Rail Tie Wind Project Final Environmental Impact Statement

DOE/EIS-0543
November 2021

**Western Area
Power Administration**

Figure 1. "Modeled Received Sound Levels" (Report Figure 2).

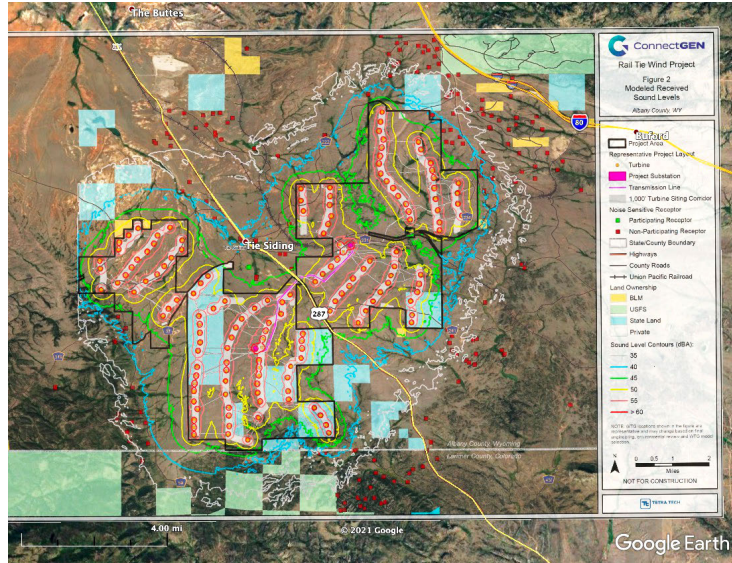
10. Whereas, the Report uses the Leq average sound level for its sound modeling, ignores known noise fluctuations, and concludes that the Project will not exceed 55 dBA at all project property lines. See this review's Figure 1 below, which provides the Report's predicted average sound levels.

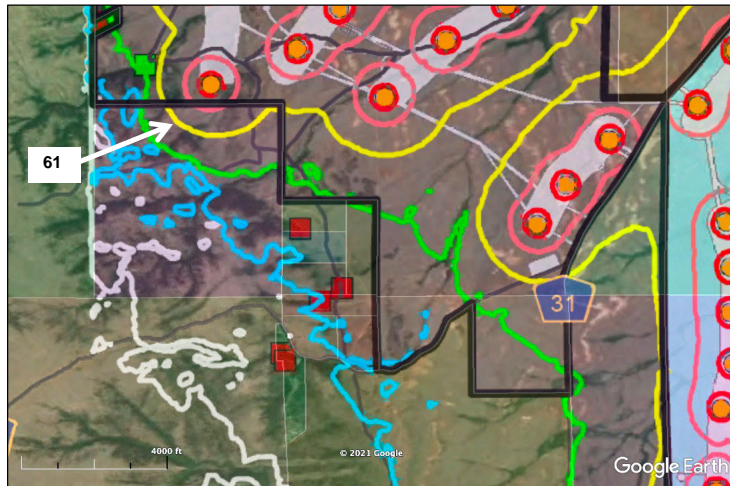
11. This review's Figure 2 below provides the Report's predicted average sound levels closer up, at the southern project property lines. Conservative adjustments of +11 dB are noted based on documented wind turbine fluctuations discussed earlier. Fluctuations include amplitude modulation occurring at the blade pass rate and coincident addition of multiple turbines' modulating noise emissions. The conservative adjustments show the highest fluctuating sound levels associated to the Report's predicted contour levels.

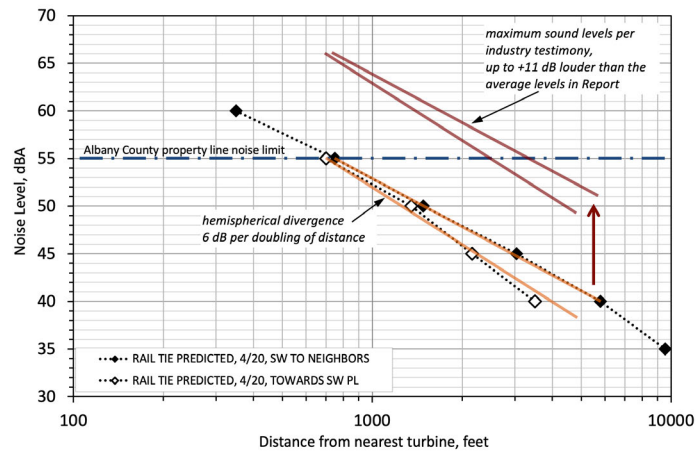
15. To review fluctuating level impacts, Report Figure 2 was imported into Google Earth Pro and scaled at the project location with a tolerance of +/- 50 feet. Project-predicted sound level versus distance was assessed by measuring distance to contours for two locations; 1) a turbine set apart from others, where hemispherical divergence could be obtained (6 dB per doubling of distance, the expected drop with distance for a sound source), and 2) sound levels with distance for a line of turbines, where the drop with distance is generally in the range of 3 to 6 dB per doubling. The results are shown in Figure 3 below.

17. As seen in Figure 3, once industry measured fluctuating decibel ratios are factored in: depending on turbine proximity to other turbines, a setback from property line of roughly 1/2 to 2/3 mile feet is needed to comply with County property line noise limits.

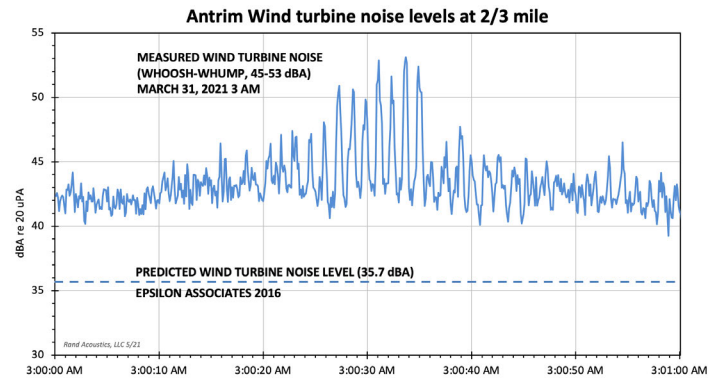
20. Real test data show that wind turbine noise is not "steady" and can significantly exceed predicted noise levels.
21. The WHO 2009 publication on Night Noise Guidelines [9] "offers guidance to policy-makers in reducing the health impacts of night noise, based on expert evaluation of scientific evidence in Europe." WHO Lmax sleep disturbance thresholds are shown below; "...all effects are summarized for which sufficient and limited evidence exists. For these effects, the threshold levels are usually well known, and for some the dose-effect relations over a range of exposures could also be established."(emphasis added). Indoors Lmax thresholds are noted in the figure below.

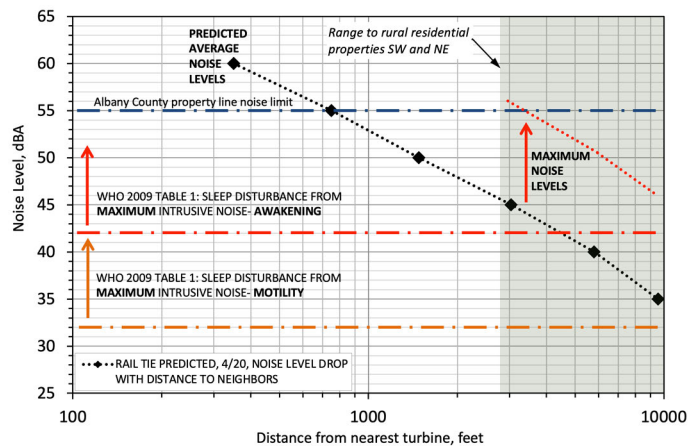
24. Probable maximum noise levels in Figure 6 should be compared to the indicated WHO indoors sleep health thresholds 32 and 42 dBA L_{max,inside} by subtracting 1-3 dBA from maximum outdoors noise levels (Vermont testing by two independent firms of large wind turbine outdoor to indoor noise reduction, 2014 [11]).

Figure 7. Noise predictions show facility intrusive noise levels would breach ANSI S12.9 guidelines for compatibility with rural residential land use at night at nearest residential properties southwest and northeast of the proposed facility.

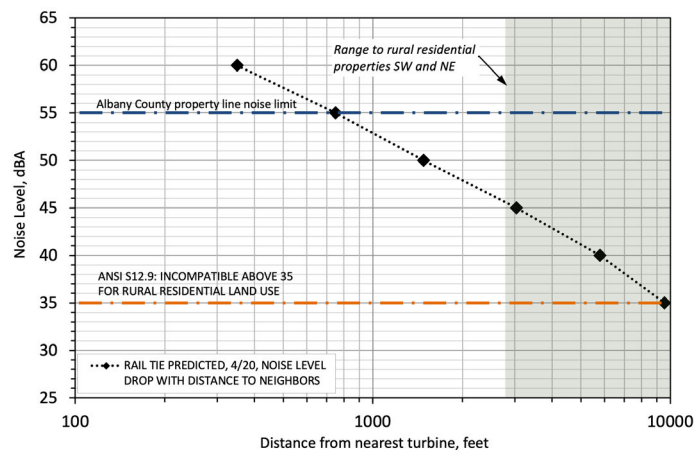
25. The American National Standards Institute (ANSI) provides land use compatibility guidelines in S12.9 Parts 4 & 5. In short, long term average unfamiliar, intrusive sound levels under 30 dBA are compatible and levels over 35 dBA are incompatible with quiet rural residential land use at night (amenity). See this letter's Figure 7. Predicted facility noise levels are certain to breach ANSI threshold for incompatibility with quiet rural residential land use out to some two miles.

26. ANSI land use compatibility speaks directly to impacts on rural serenity and amenity. When ANSI compatibility guidelines are observed for quiet rural land use, serenity and amenity is preserved. Whereas, the facility as currently designed predicts degradation of the nighttime rural amenity.
